Date: July 10, 2007

To: T10 Committee (SCSI)

From: George Penokie (IBM)

Subject: SAS-2: More Transport level read fixes

Figure 1 — Representation of transport layer (i.e., ST_ITS6) read data operation

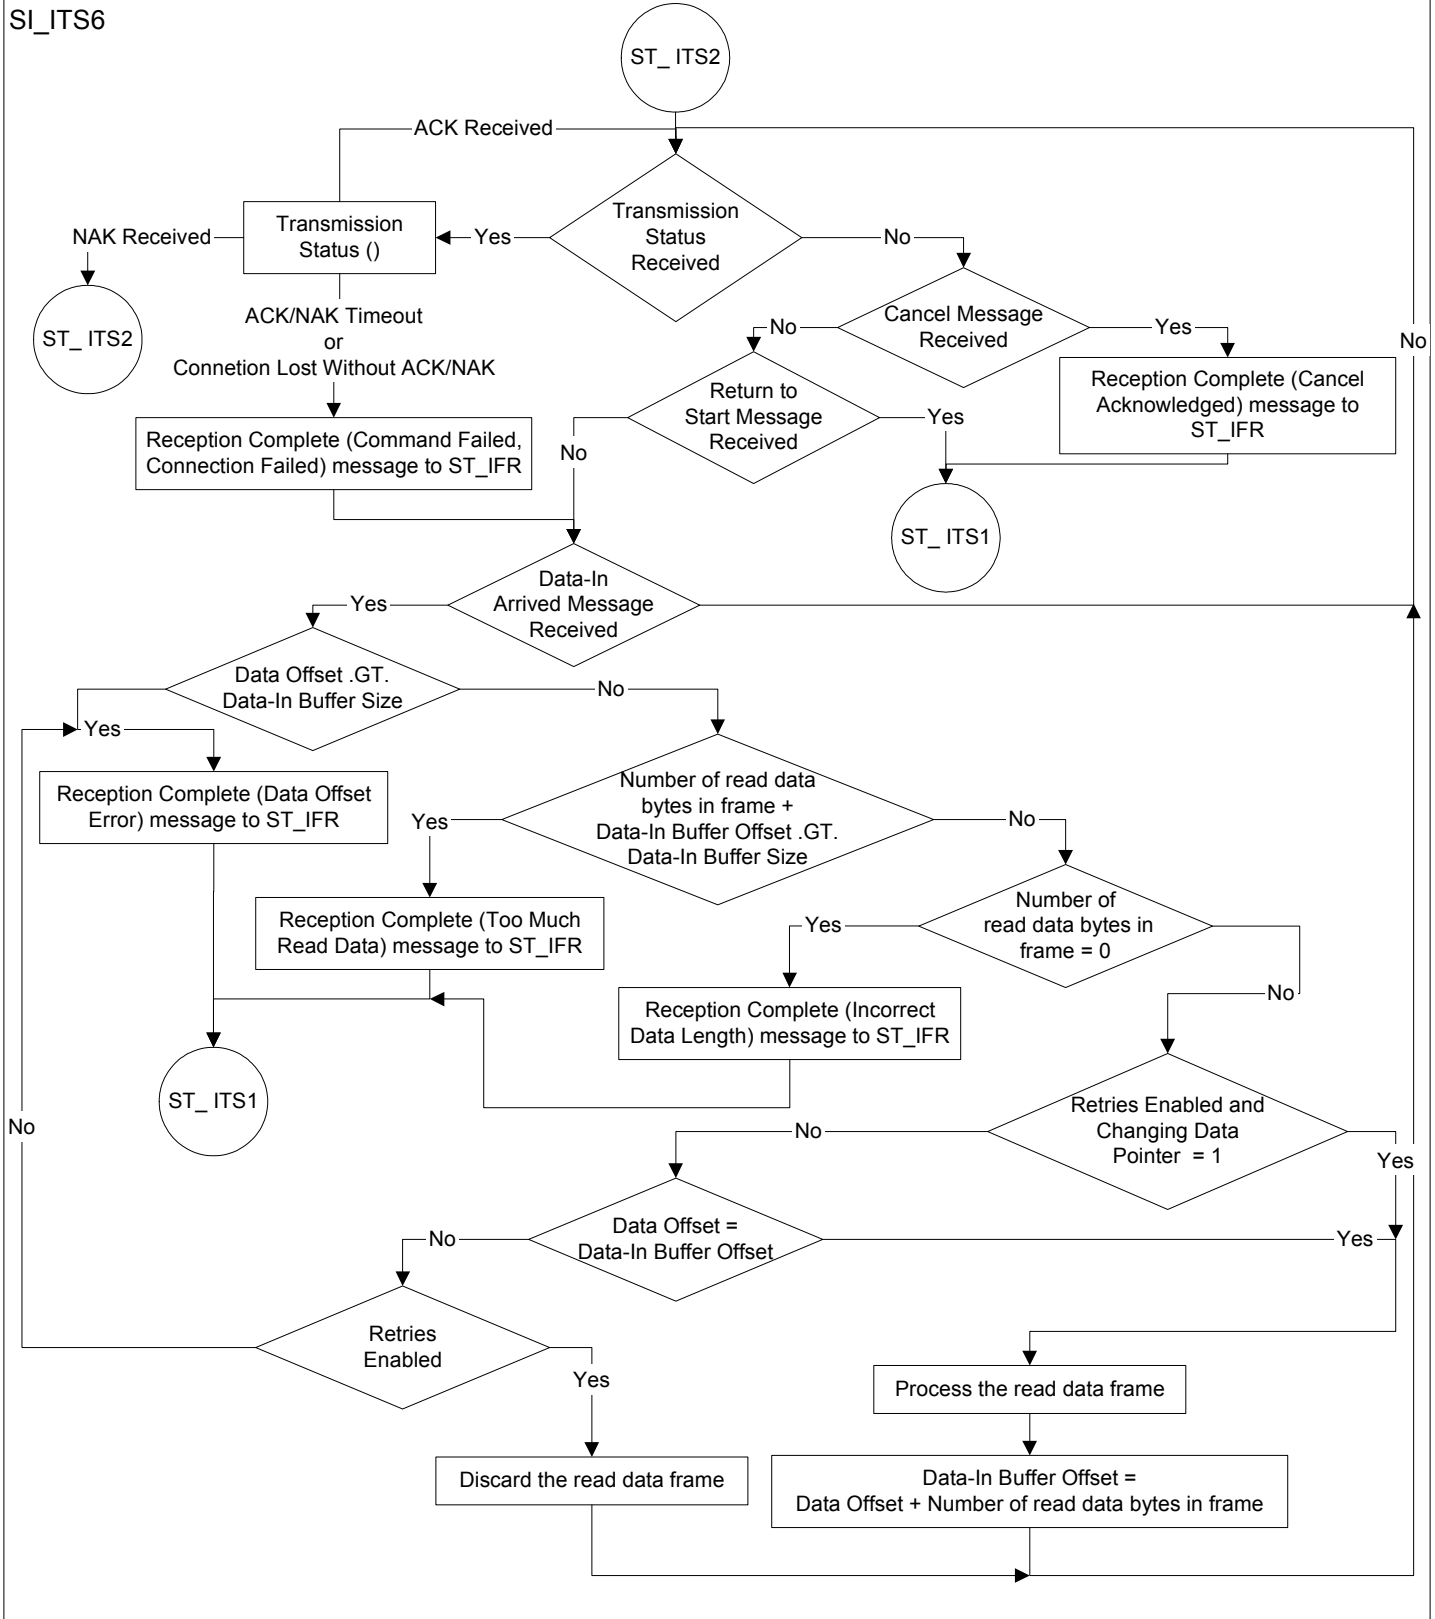
DATA OFFSET field = Contains the first offset location into read data buffer for the current DATA information unit
 Data-In Buffer Offset = Offset into read data buffer for the last received data frame.
 Data-In Buffer Size = The number of bytes to be read as requested by the application client.

Figure 2 — Representation of transport layer (i.e., ST_TTS1 and ST_TTS3) read data operation

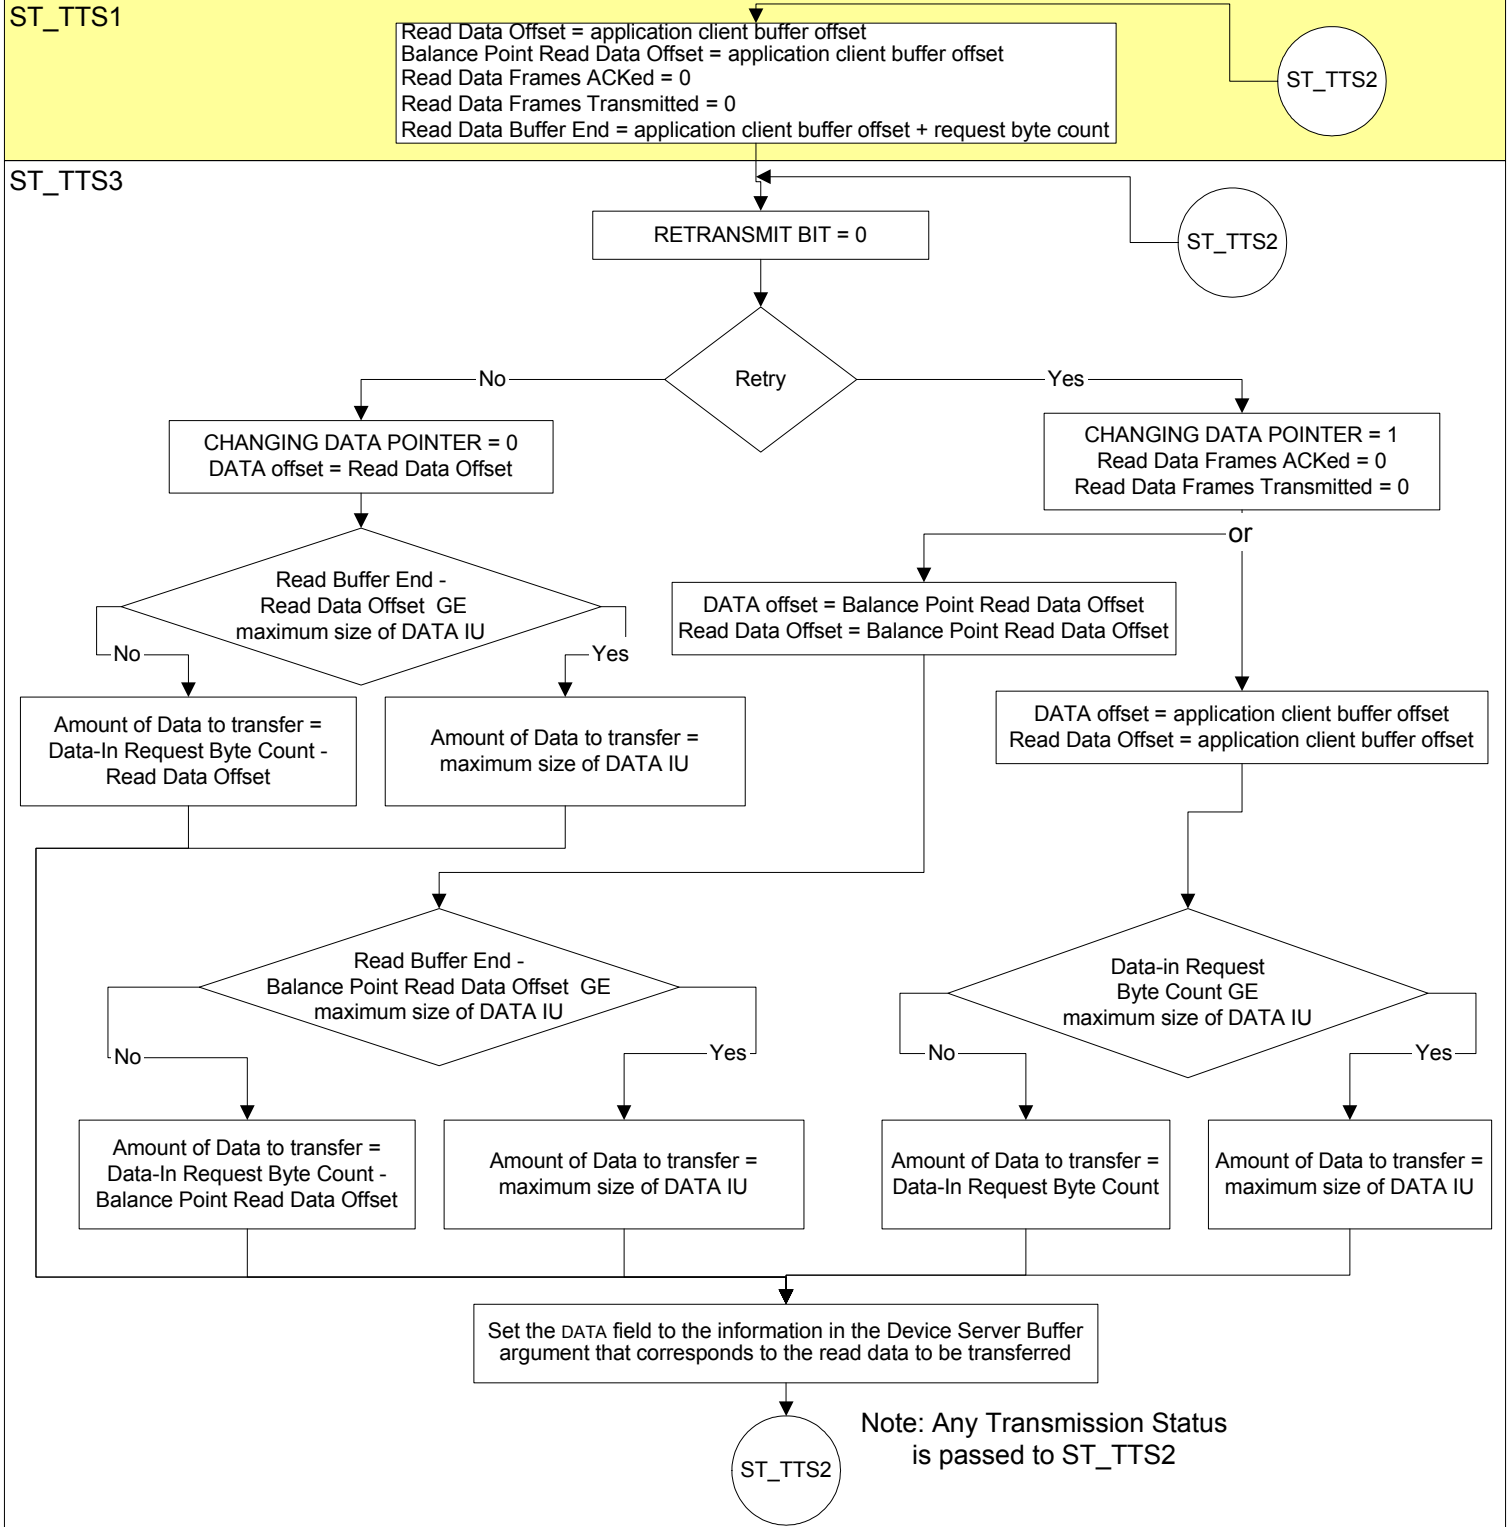
Read Data Offset = Offset into application client read data buffer

Balance Point Read Data Offset = Offset into the application client read data buffer for last data frame that the number of frames transmitted = number ACKs received

Read Data Buffer End = Offset into the application client read buffer of last location into which data may be placed

Figure 3 — Representation of transport layer (i.e., ST_TTS2) read data operation (part 1 or 2)

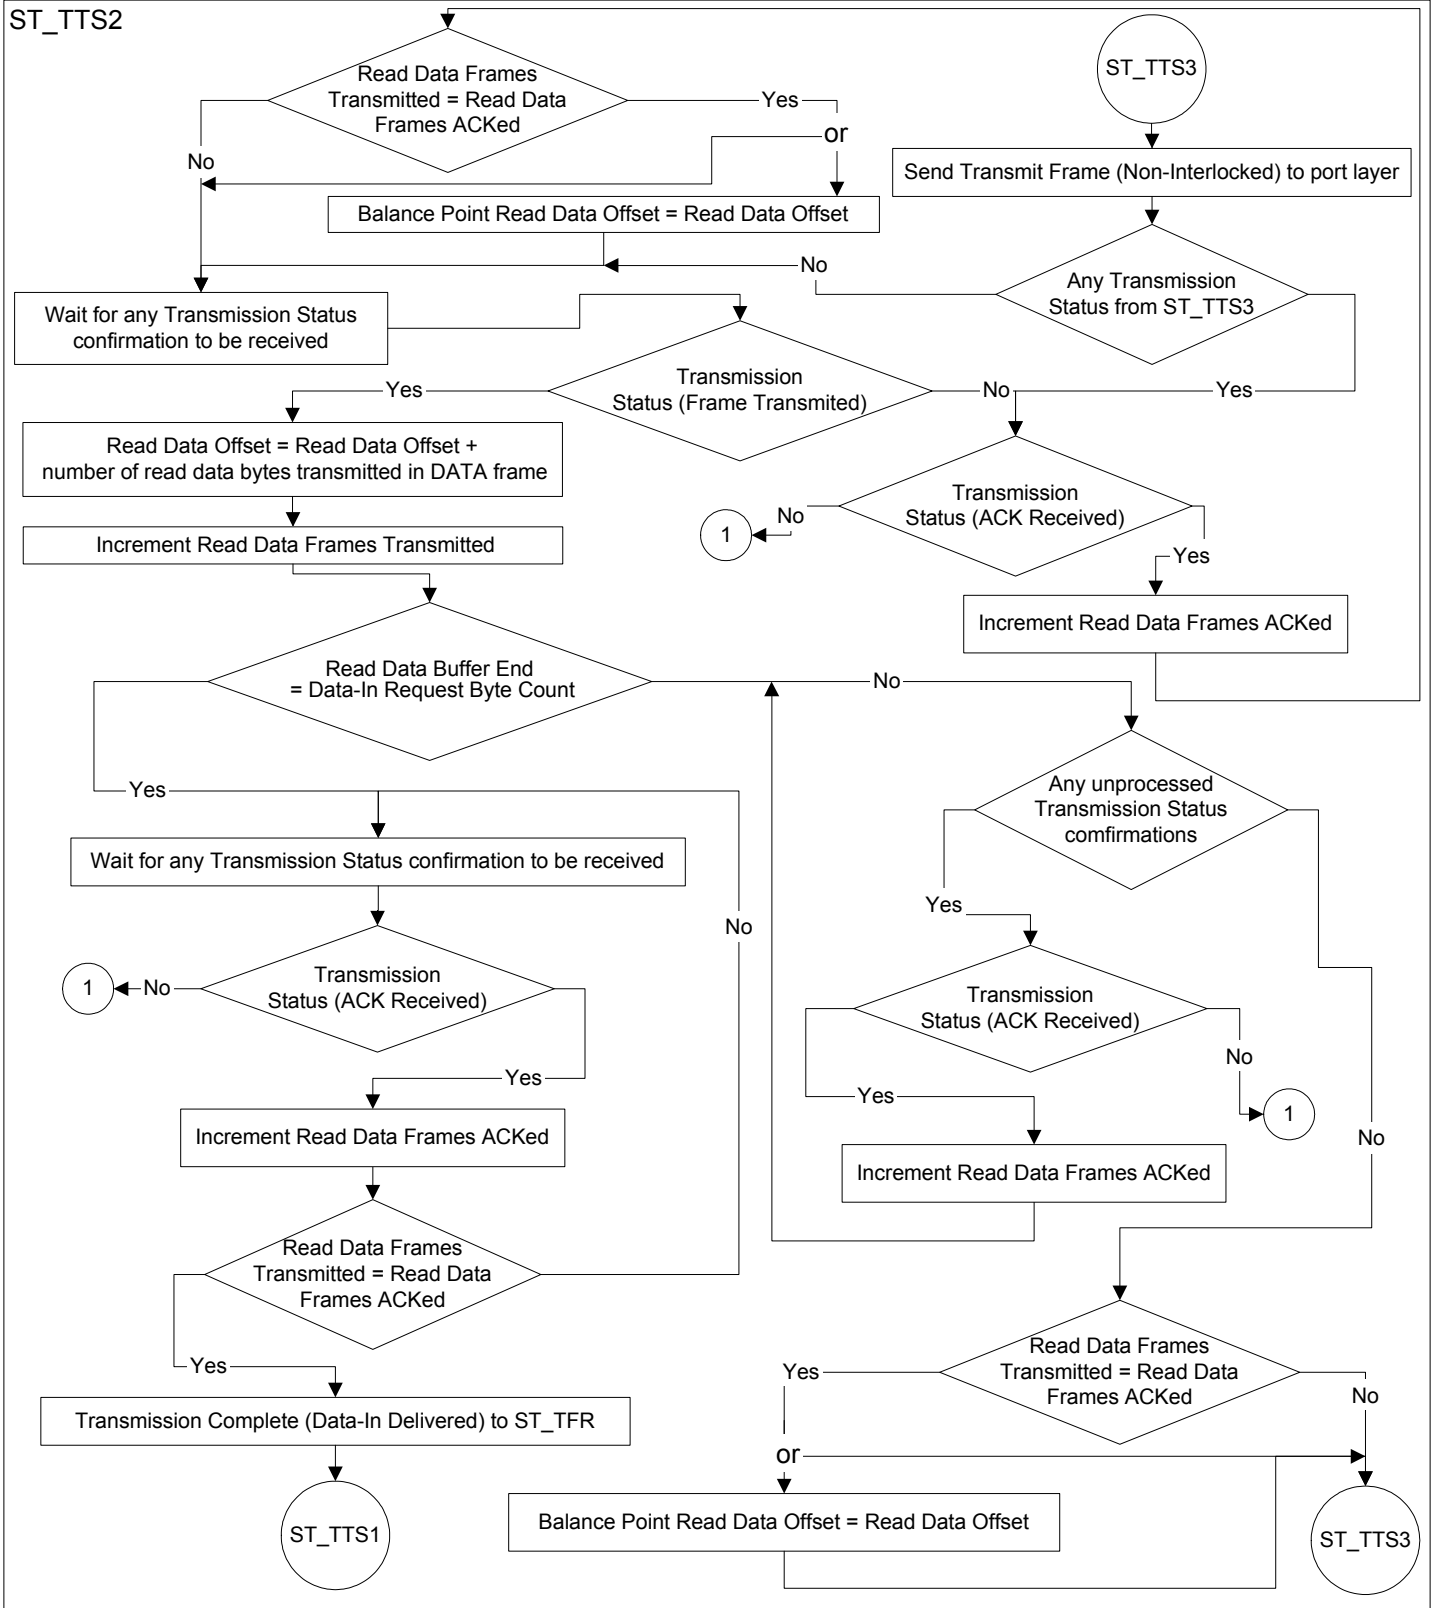
Read Data Frames Transmitted = The number of Transmission Status (Frame Transferred) confirmations received
 Read Data Frames ACKed = The number of Transmission Status (ACK Received) confirmation received.
 Balance Point Read Data Offset = Offset into the application client read data buffer for last data frame that the number of frames transmitted = number ACKs received
 Read Data Buffer End = Offset into the application client read buffer of last location into which data may be placed
